# Access Compliance Report

## Public Rights-of-Way

### (Curb Ramps)

Intersection ID: 52771	Main Street: DESIGNER_DR	Cross Street: OUTLETS_BV	Location: SE
ADA ID: 0394F34D6FD3	Ramp Type: Perp	Initial Pass/Fail: Fail	Overall Compliance: No
Codes/Mitigation Info/Possible Solution		Field Measurements/Component Compliance	
Severity Score: 13.75

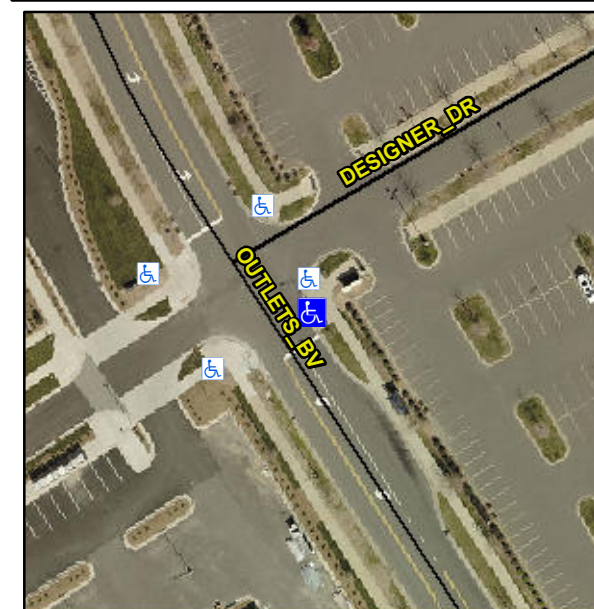
**Not Found, R304.2.2**

Compliance	Description	Data	Compliance	Description	Data
N/A	Ramp Length (in)	96.0	No	Ramp Slope (%)	8.4
Yes	Ramp Width (in)	48.0	Yes	Ramp XSlope (%)	2.4
N/A	Flare Type LT	N/A	N/A	Flare Type RT	N/A
N/A	Flare Slope LT (%)	N/A	N/A	Flare Slope RT (%)	N/A
N/A	Flare Traversable LT?	N/A	N/A	Flare Traversable RT?	N/A
N/A	Landing Length (in)	N/A	N/A	DWS Provided?	N/A
N/A	Landing Width (in)	N/A	N/A	DWS Contrast?	N/A
N/A	Landing Slope (%)	N/A	N/A	DWS Length (in)	N/A
N/A	Landing X Slope (%)	N/A	N/A	DWS Full Width?	N/A
N/A	Landing Curb? (Y/N)	N/A	N/A	DWS Offset (in)	N/A
N/A	Shared Landing?	N/A			
N/A	Gutter Ponding?	N/A	N/A	Gutter Slope (%)	N/A
N/A	Gutter Lip Ht (in)	N/A	N/A	Gutter X Slope (%)	N/A
N/A	Painted X Walk1?	No	N/A	Painted X Walk2?	N/A
	X Walk 1 Direction	To W		X Walk 2 Direction	N/A
N/A	X Walk 1 Width (in)	N/A	N/A	X Walk 2 Width (in)	N/A
	X Walk 1 Slope (%)	2.8		X Walk 2 Slope (%)	N/A
	X Walk 1 X Slope (%)	2.9		X Walk 2 X Slope (%)	N/A

**Remove & Replace Entire Ramp.**
